UNITED STATES PATENT AND TRADEMARK OFFICE

APPLICATION NO.	FILING DATE	FIRST NAMED INVENTOR	ATTORNEY DOCKET NO.	CONFIRMATION NO.
09/011,160	01/20/1998	HAROLD RALL		9528

Office Action Summary	Application No. 09/011,160	Applicant(s) HALL, HAROLD	
	Examiner Mr. Terry K. Cecil	Art Unit 1723

DETAILED ACTION

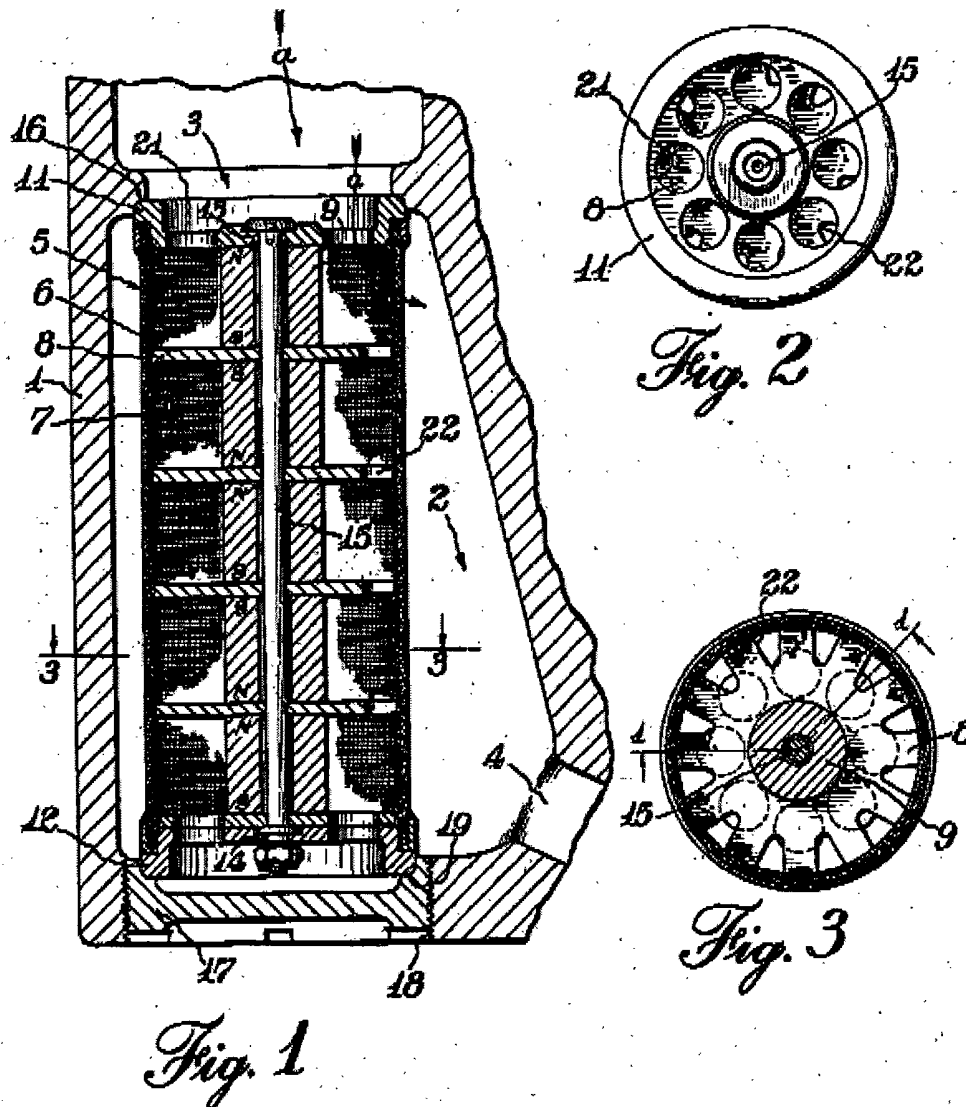
3. Claims 12-13, 15, 20, 22-24, 27-31 and 33-41 rejected under 35 U.S.C. 102(b) as being anticipated by Frei (U.S. 2,149, 764).

As shown above, Frei discloses the all limitations of the aforementioned claims including the metal plates and magnets having faces of opposite polarity; the plates include aligned recesses for fluid flow. The arrangement allows for capturing of magnetic particles flowing in the fluid

through the filter unit 5, the fluid is forced to flow by the multitude of edges and corners provided by the magnetized baffle plates, and the magnetic material in the fluid adheres to such edges and also to the wires of the screens 8 and 7 which are also magnetized by their engagement with the peripheries of the baffle plates.

[as in claims 12, 22-23, 27, 30, 31 and 40]. Because of the arrangement, the plates are alternately charged such that regions are formed that would repel some particles, depending upon their charge [as in claims 13 and 28]. Distribution plates (11, 12) are also taught having apertures aligned with the plate recesses [as in claim 15]. As shown in figure 5, additional recesses ("slots") are taught. Also in figure 3, the notches 22 can be considered as a series of alternating recesses and slots [as in claim 20]. As for claim 24, plate 11 is thicker than plate 8 [as in claim 24]. Filter screen 5 is positioned downstream of the plates and magnets [as in claim 29]. As for claims 33-34, notches 22 formed pole pieces therebetween that extend radially past the magnet surfaces. As for claim 35, every other notch 22 can be considered a "radial slot" formed in a pole piece. The centrally located plates are of a common configuration [as in claim 37-38]. As for claims 39 and 40, the device can be unassembled because of bolt 15.
